### March 22, 2016 Medway Planning and Economic Development Board Meeting Medway Middle School - 45 Holliston Street Medway, MA 02053

### **Salmon/Willows ARCPUD Continuation:**

### Eversource Site Plan - Public Hearing Continuation.

### Exelon Site Plan Public Hearing:

Salmon Health & Retirement Landscape Plan - Buffer Enhancement Plants

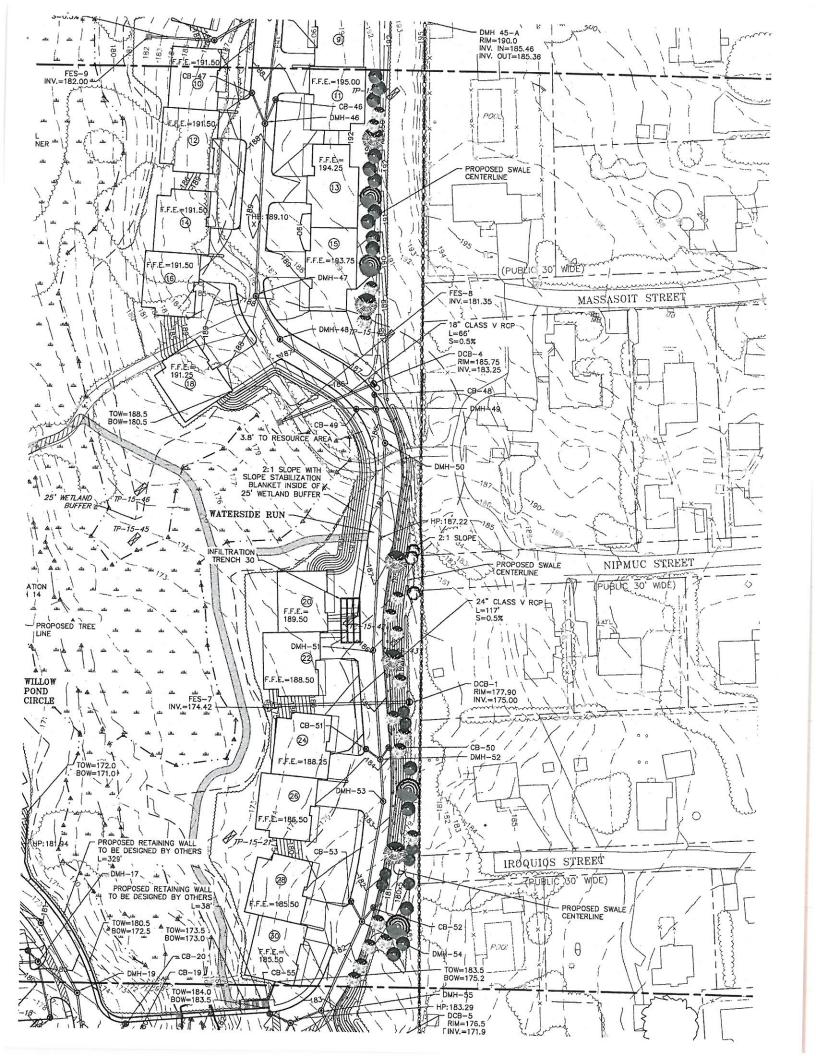
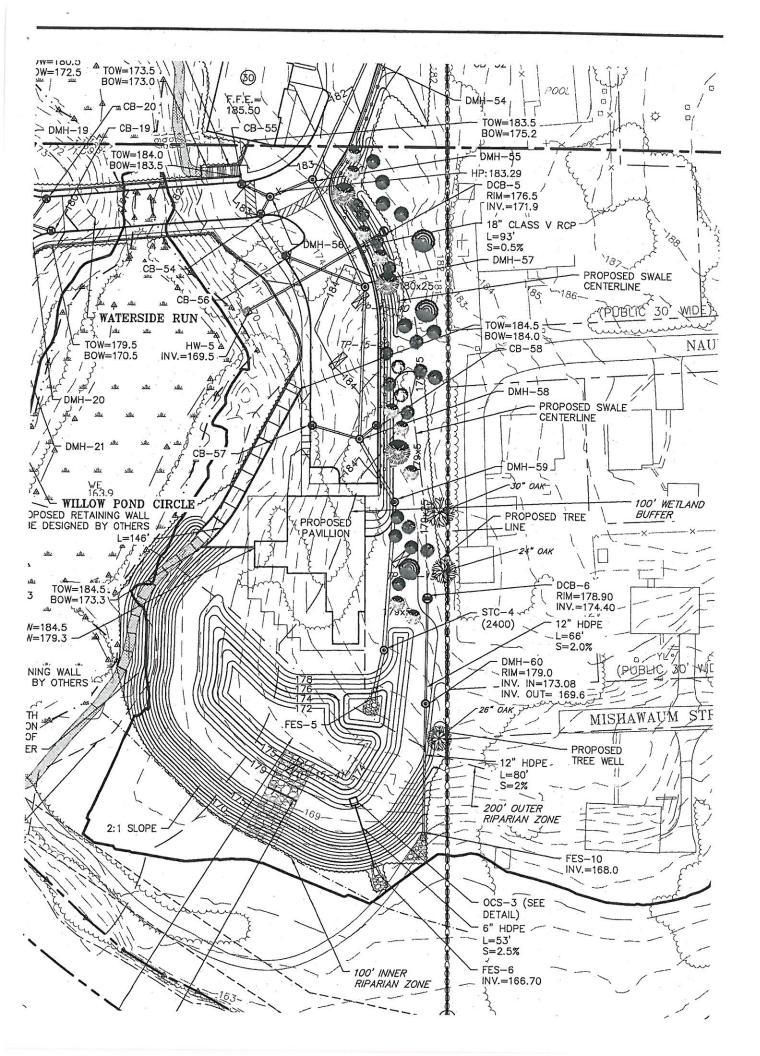
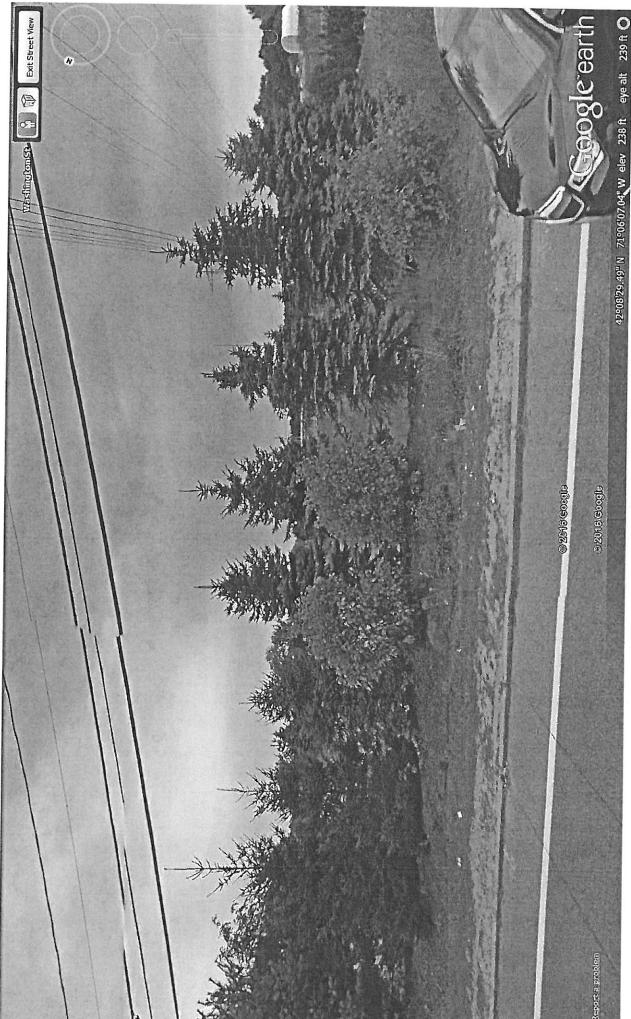
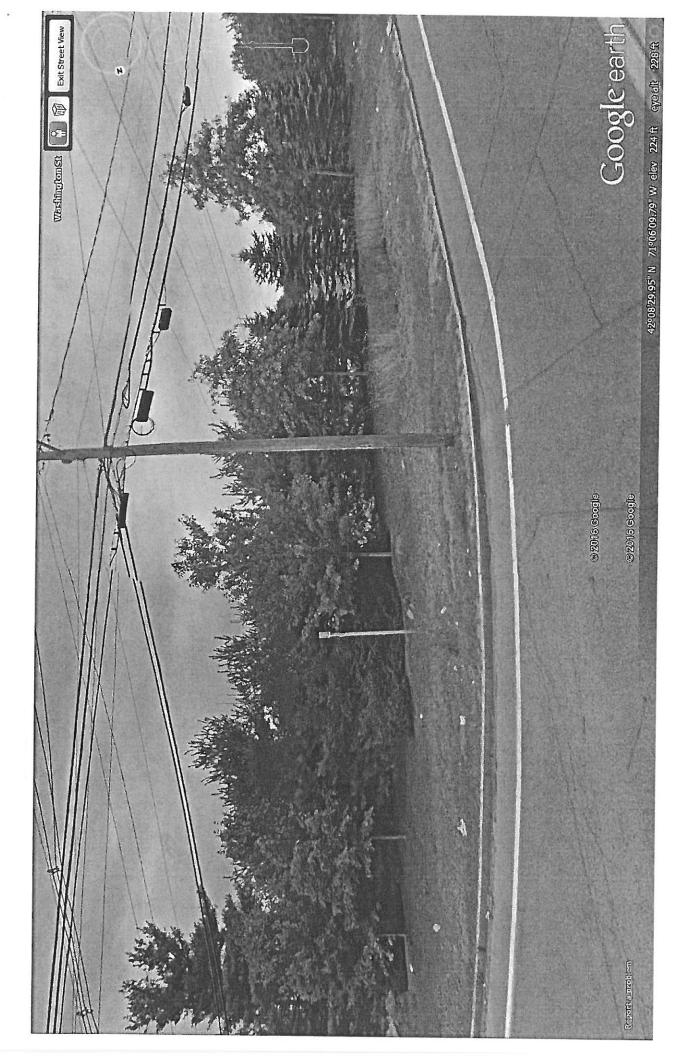
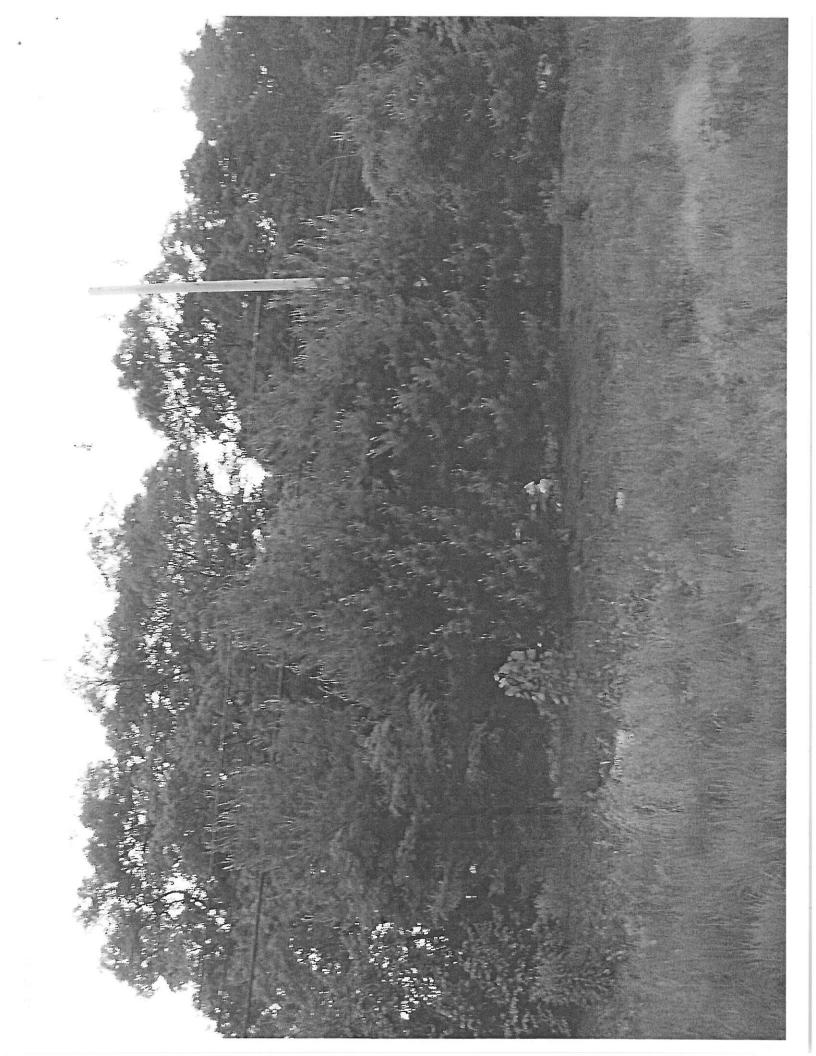
The DRC discussed this matter again at its March 21st meeting and reviewed the above noted landscape drawing. The DRC believes the inclusion of a variety of shrub species is appropriate, but they must be planted in conjunction with taller growing evergreen tree species to achieve an acceptable buffer. That is, the examples shown during the meeting by Mr. Thompson would provide a complete screen from the ground to a minimum height of approximately 8 feet. Shrubs alone cannot provide this same amount of screening. Any shrub like plantings should be of a large initial size of 6 feet or greater to provide immediate screening.

NOTE: Plants and plant locations shown relating to this Plant Key are in addition to the plants designated on the Salmon Health & Retirement - Landscape Plan, date 2/18/16.

Re: Faux Windows at Tri Valley Commons

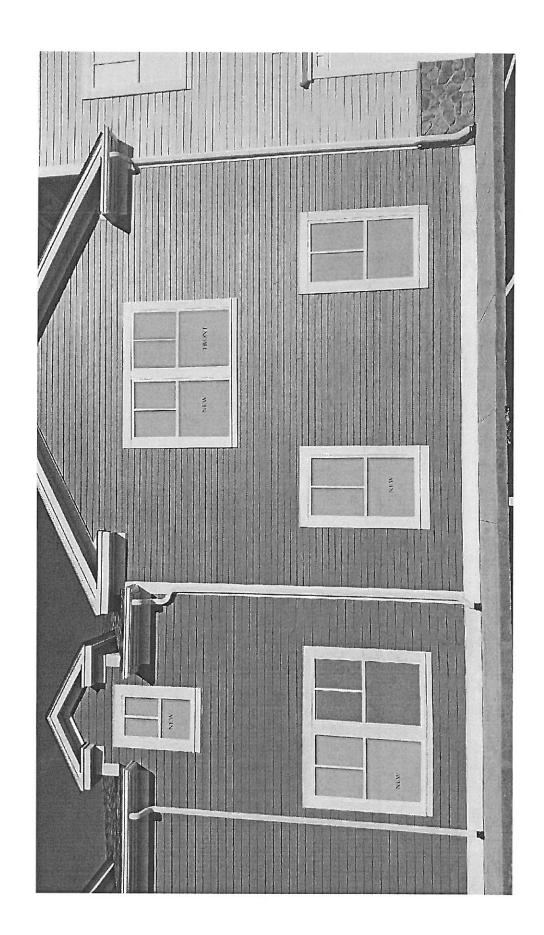
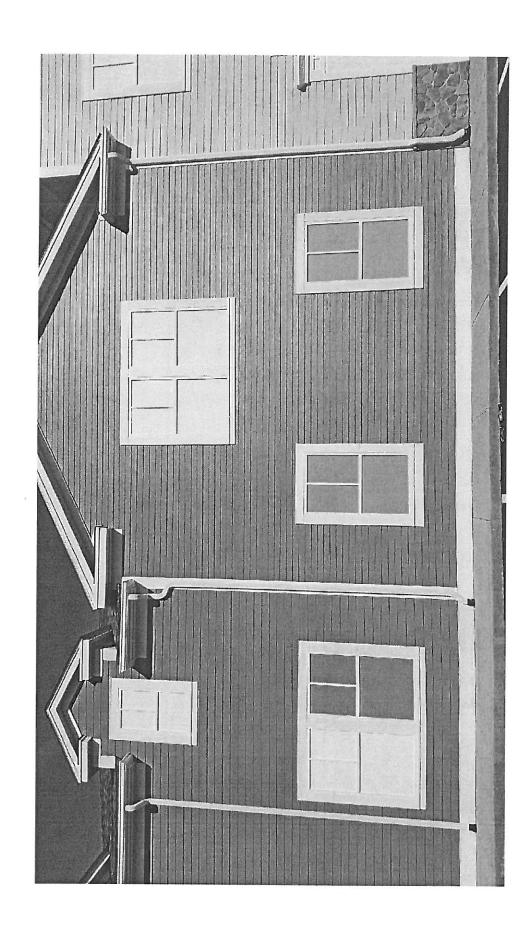
We have received a request from Barry Steinberg of Direct Tire. He would like to NOT have two faux windows installed on the northern end of the east facing façade of the Direct Tire Building. See attached emails and Sheet 18 from the endorsed revised Tri Valley Commons plan set with a comment note from me showing the location of the subject windows.

The Board was made aware that Direct Tire owner Barry Steinberg is requesting that two faux windows not be installed on east façade of Direct Tire building. The Design Review Committee recommends approval of Mr. Steinberg's request. The Building Commissioner sent an email indicating that the scope of the modification is an insubstantial change. Developer Rich Landry agrees with the requested change.
